Docket Number 50-346

United States Nuclear Regulatory Commission
Document Control Desk
Washington, D. C. 20555-0001Subject: Response to Questions Regarding the 2002 Steam Generator Tube Inspections
(TAC No. MB9541)

RESPONSE TO QUESTIONS ON LICENSEE'S RESPONSES
TO REQUEST FOR ADDITIONAL INFORMATION
DAVIS-BESSE NUCLEAR POWER STATION
2002 STEAM GENERATOR INSPECTION (TAC No. MB9541)

Voltage Distribution for Dents Between LTS and 14S
 DBNPS SG 2-A 02/02 13RFO

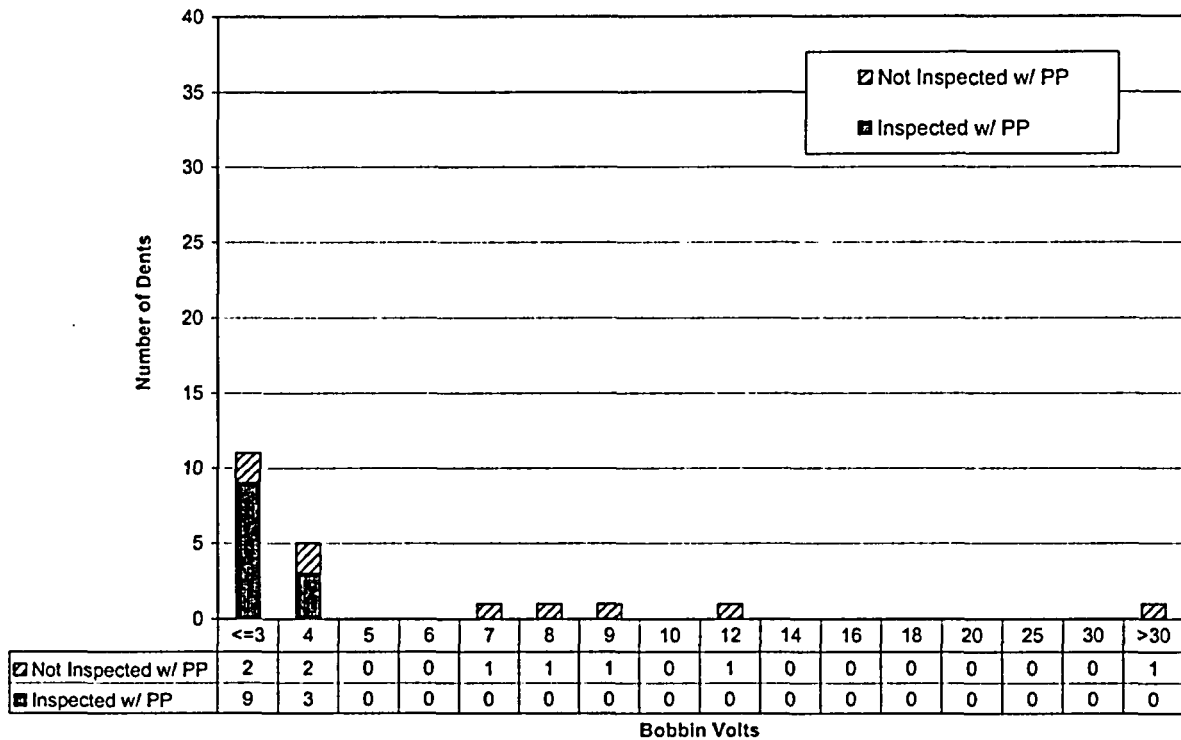
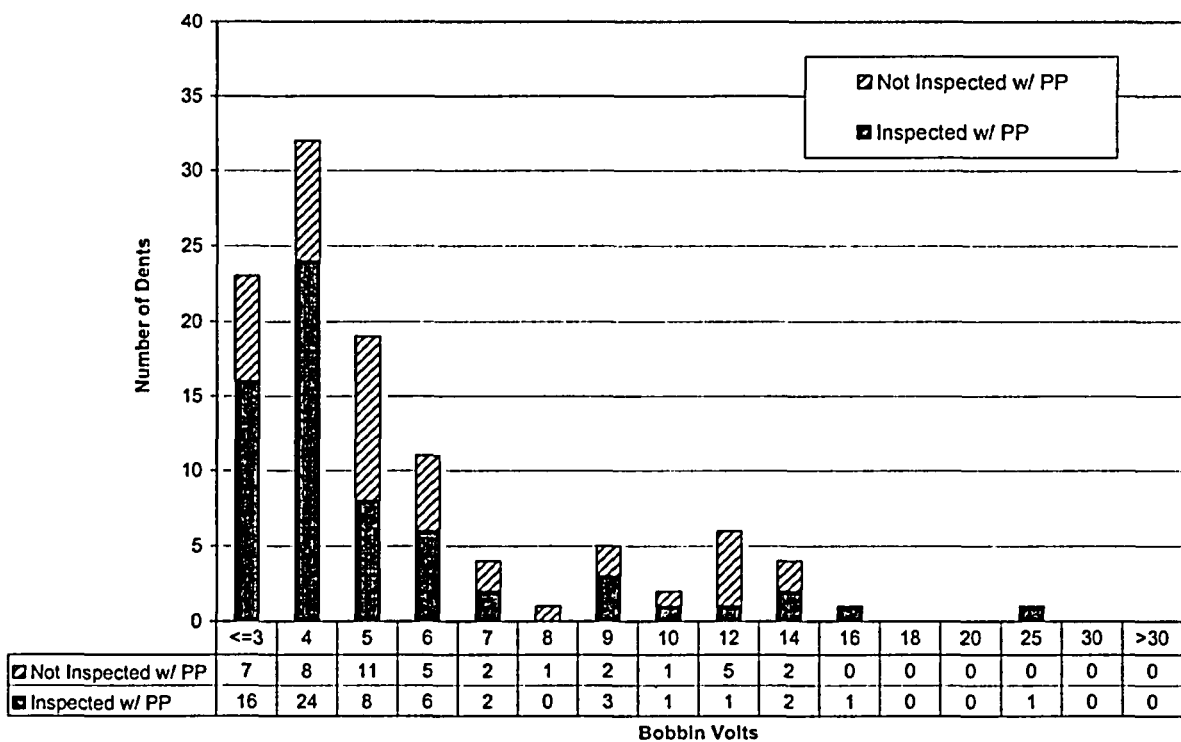
For the dents not examined during the 2002 outage, please describe the methodology used to assess the integrity of these tubes for the period of time between inspections. Include in this response, the size distribution of the dents not inspected and an assessment of whether the bobbin would have detected axial and circumferential cracks at these locations (given the size of the dent).

As previously stated, 100% of the dents located at or above the 14th TSP were inspected during 13RFO, and for dents below the 14th TSP, the DBNPS completed a 100% sample in three cycles with no indications of degradation present in any of the inspections. As requested, the figures provided below indicate the inspected versus uninspected population of dents in the region below the 14th TSP (not including dents at or in the LTS region) during the 13RFO inspection. Note that the 30 volt dent in A-61-109 was inspected in 12RFO with a +Point probe and no degradation was detected (dent present in history). Sampling in both OTSGs at the LTS sludge and dented region is accomplished under a separate inspection program.

no expansion of the dent inspection scope was performed at 13RFO and the tube integrity analyses did not include any adjustments for the uninspected dent population. As demonstrated by the Figures, the inspected population provided a sufficient interrogation of dents such that if degradation existed in this region, the sample would have been sufficient to provide a high probability of detecting active degradation in the sample. At the next scheduled inspection of the OTSGs, the DBNPS is planning on inspecting 100% of all dents in all areas of the OTSGs, as well as preventive plugging of significant dents in the region at or above the 14th TSP in the periphery (damaged from auxiliary feedwater (AFW) header issues), where existing conditions (temperature, flow, loads) could accelerate tube degradation at the dented area.
